ADDENDUM NO. 4

**HVAC & BAS Replacement
Waverly Regional Youth Center
Waverly, Missouri
PROJECT NO. H2314-01**

Bidders are hereby informed that the Construction Plans and/or Specifications are modified as follows:

SHEET TITLE:
**LOWER LEVEL
 ELECTRICAL PLAN**

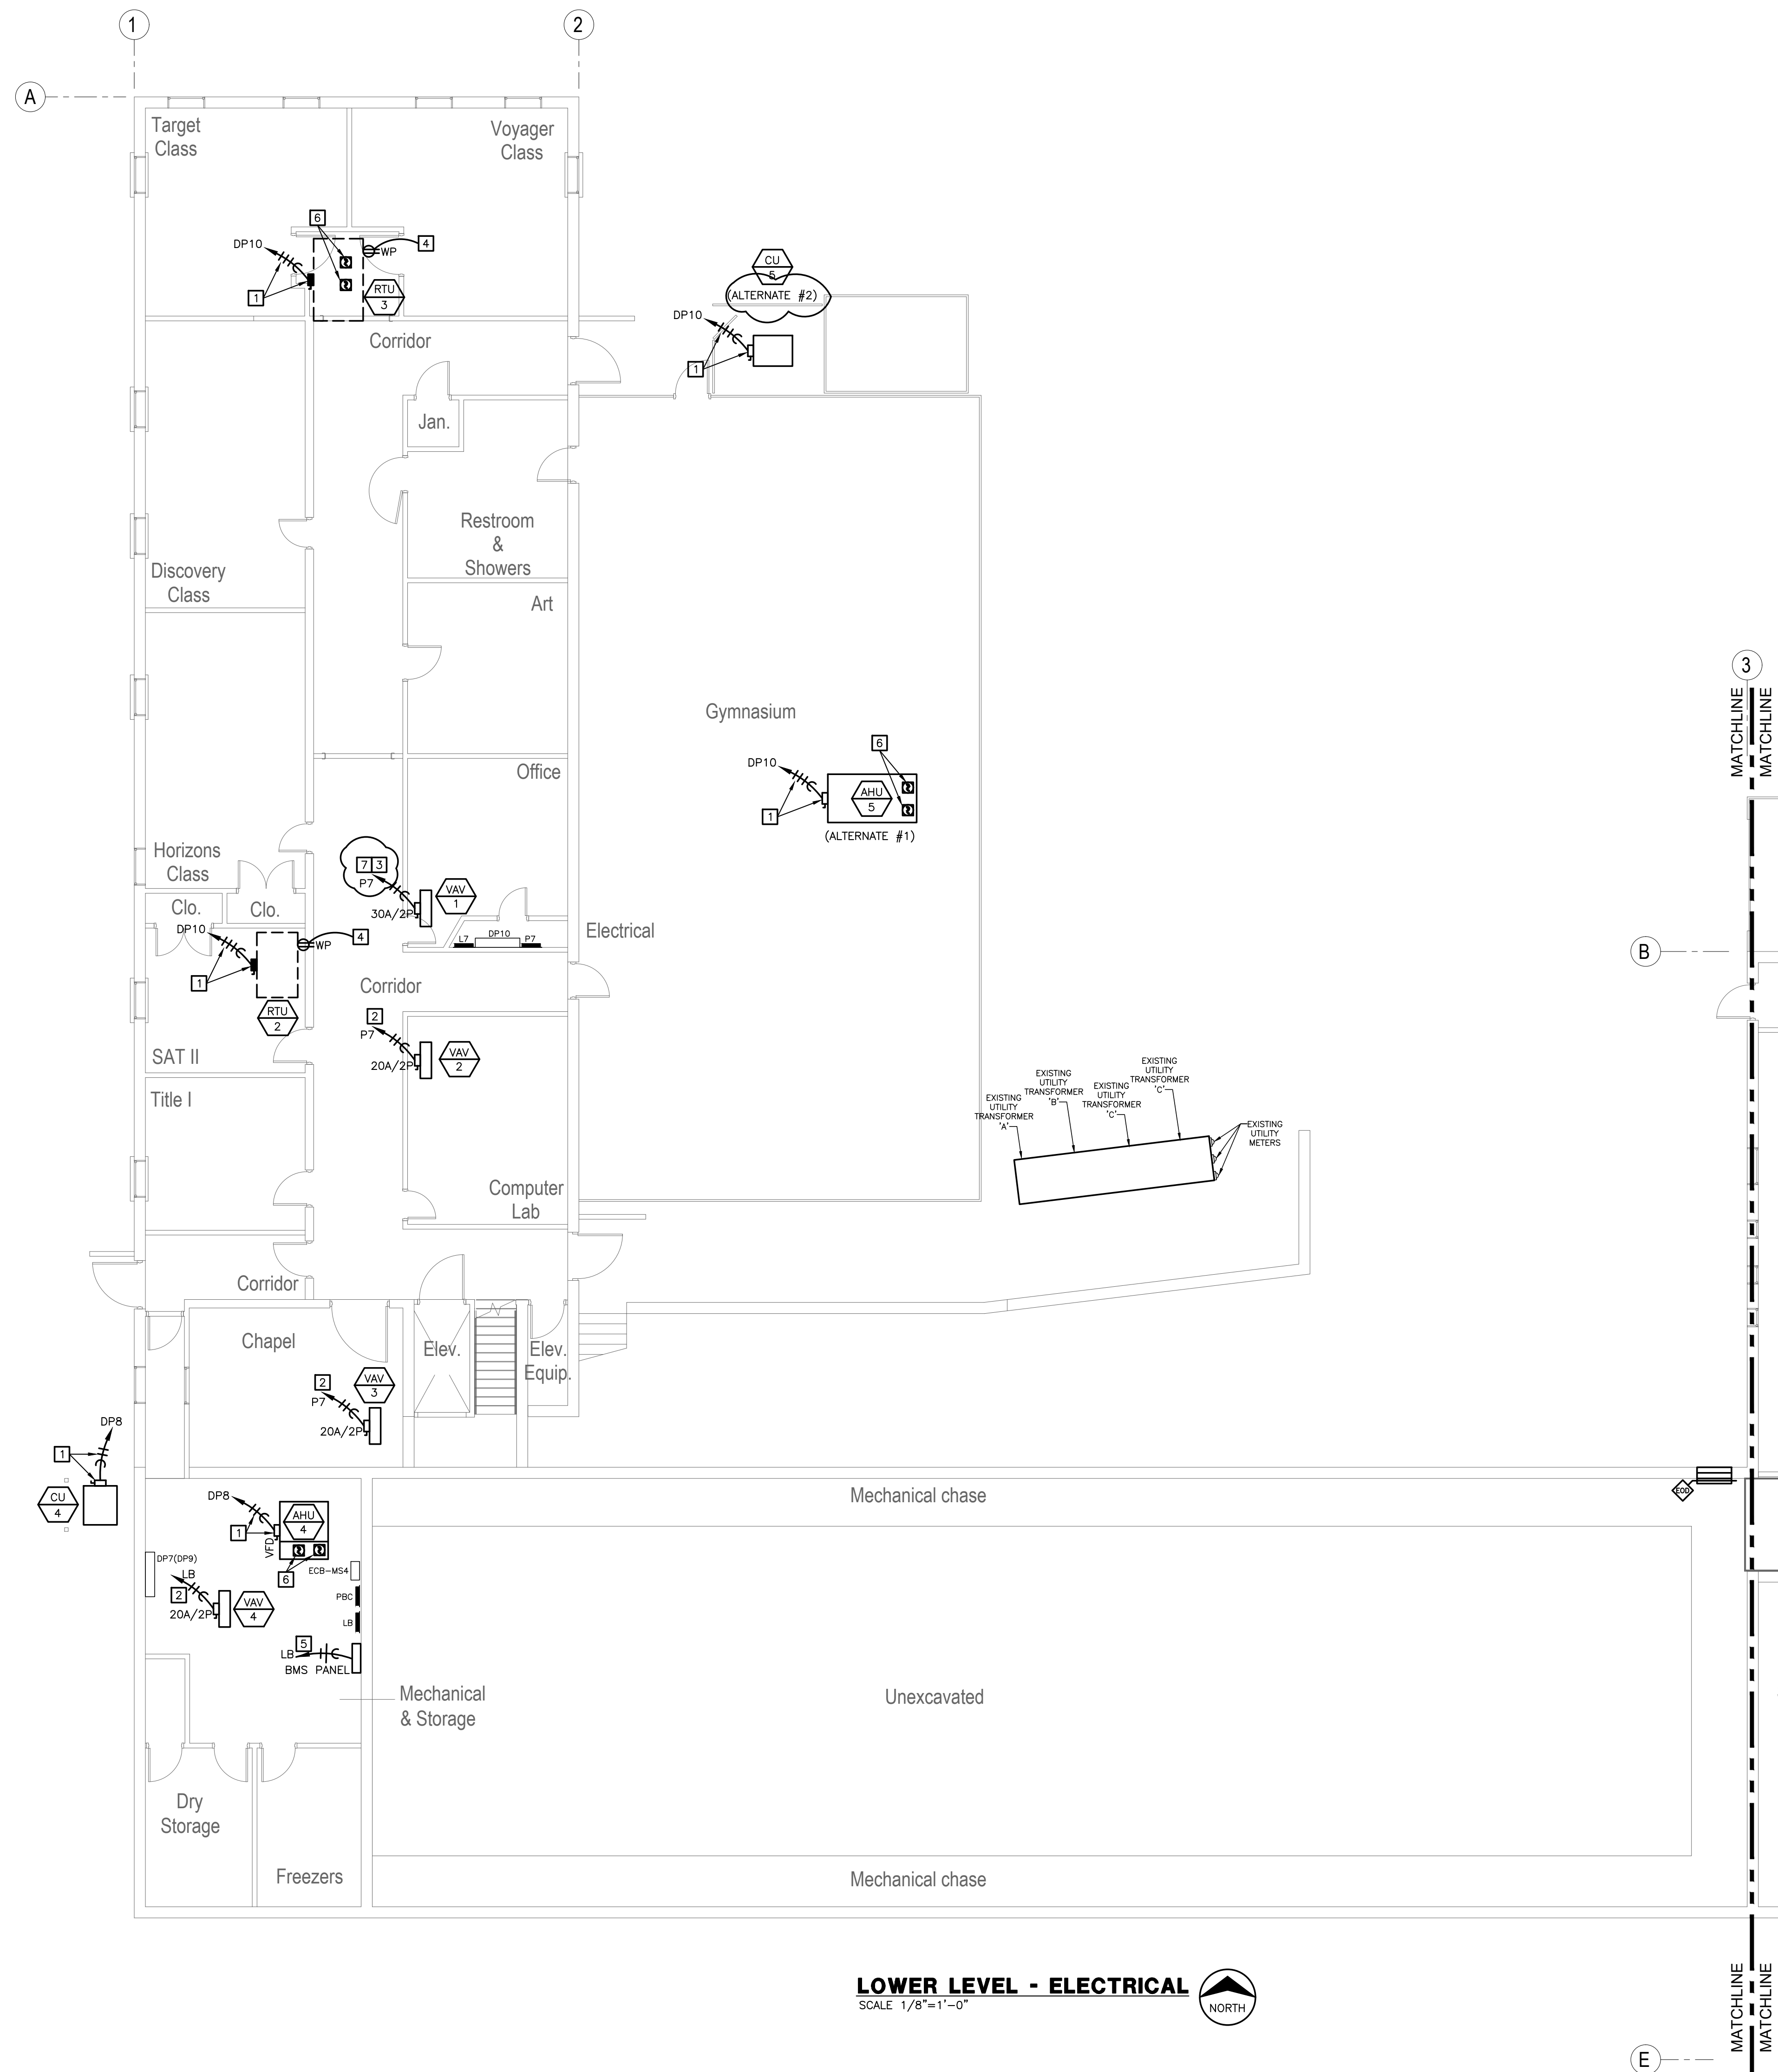
1. Sheet A121 - REMOVE abatement note from Voyagers GM room.
2. Sheet A210 - Clarification on painting wall to match existing: Patch the brick to match existing. Repaint the entire exterior wall corner to corner full height where the brick is infilled. The upper floor is not painted, only the on grade level walls where the PTAC units are removed.
3. Sheet S310 – DELETE Detail 2 is no longer required.
4. Sheet M111 – REPLACE Plan Note #3 as follows:
 - a. Fan shall be Loren Cook 135 CFS or approved equal. ¾ HP.
5. REPLACE Sheet M601 in its entirety
6. REPLACE Sheet E101 in its entirety
7. REPLACE Sheet E111 in its entirety
8. REPLACE Sheet E112 in its entirety
9. REPLACE Sheet E601 in its entirety
